PHASE I REVIEW: DOE STUDY PLAN FOR CHARACTERIZATION OF THE SITE
SATURATED-ZONE GROUNDWATER FLOW SYSTEM
(STUDY PLAN 8.3.1.2.3.1, Revision 0)

Neil Coleman

July 22, 1991

Figure 5.1-1. Summary network for Solitario Canyon and potentiometric-level activities show drilling schedule.

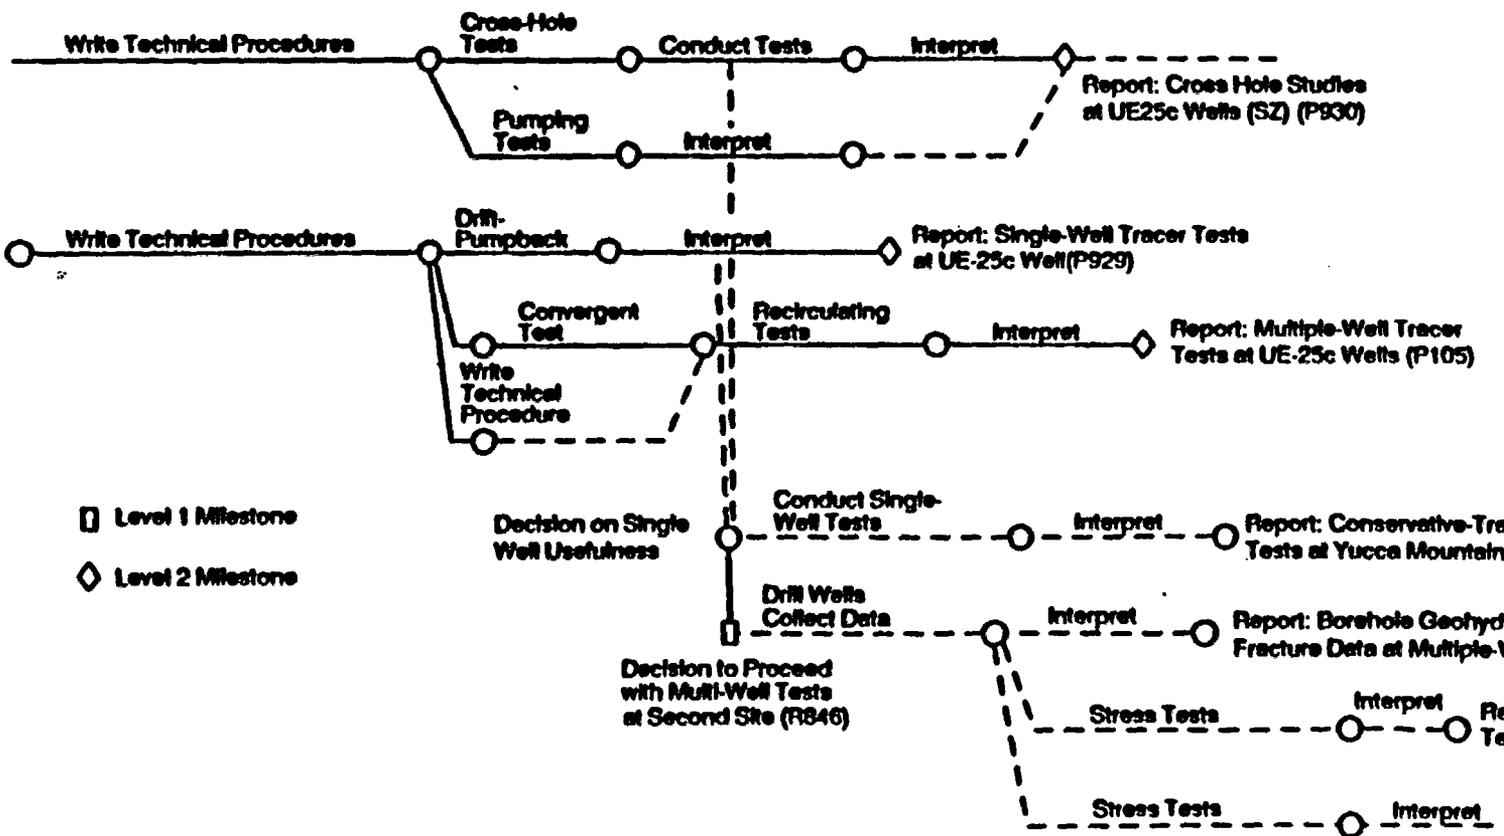
It is stated in Section 5.1 that "Specific durations, and start and finish dates for the activities are being developed as part of ongoing planning efforts". As for time interrelationships among principal activities associated with this study, it is also noted in Section 5.1 that "the testing of the saturated zone flow-system as described in this study plan will be dependent on the drilling schedules of the water-table holes". Relative time interrelationships are provided in Figures 5.1-1 and 5.1-2.

Figure 5.1-2. Summary network for hydraulic and conservative tracer tests.

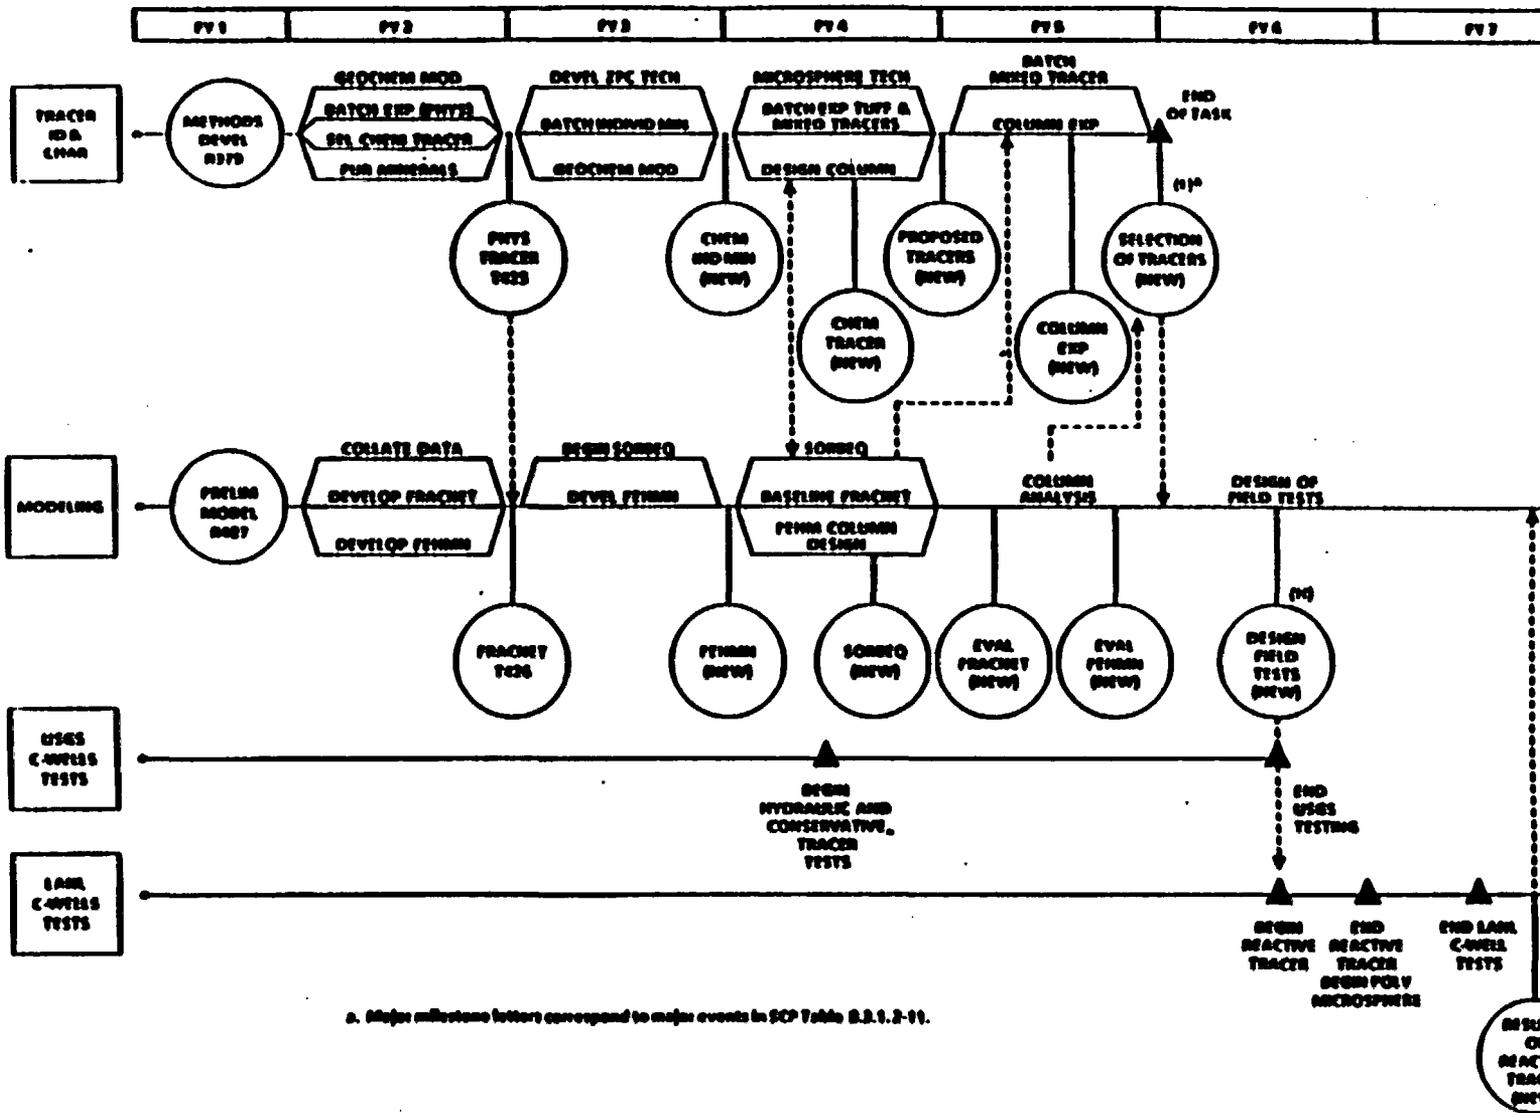
- The schedules for the USGS and LANL study plan work are attached. The USGS schedule shows that many tests are planned for the third and fourth fiscal years. These include cross-hole, pumping, drift-pumpback, and convergent tests. The LANL schedule suggests that the reactive tracer testing (and other LANL field tests) will begin when the USGS testing ends, toward the middle of the sixth fiscal year. Under the USGS schedule, the field testing at the C-hole site would end in the fifth fiscal year. Although the schedules show a planned separation in schedules between the USGS and LANL field tests, there is considerable need for mutual planning and coordination. For example, the USGS report on interpretation of multiple-well tracer tests at the C-hole site is scheduled for completion at the same time that the LANL field tests would begin. However, preliminary USGS interpretations will undoubtedly be needed earlier to finalize plans for the LANL work. Finally, given the general sequencing of studies, any delays in the USGS program will result in corresponding delays in the later LANL work.

The DOE should prepare a timeline that shows all proposed work activities under the site saturated zone investigations and any other work planned in the vicinity of the C-hole site. This timeline should include durations and start and finishing dates for all activities. If it is not yet possible to include actual start dates, then a detailed timeline should be prepared that clearly shows the relative starting times and durations for all related tests, including the LANL program of testing.
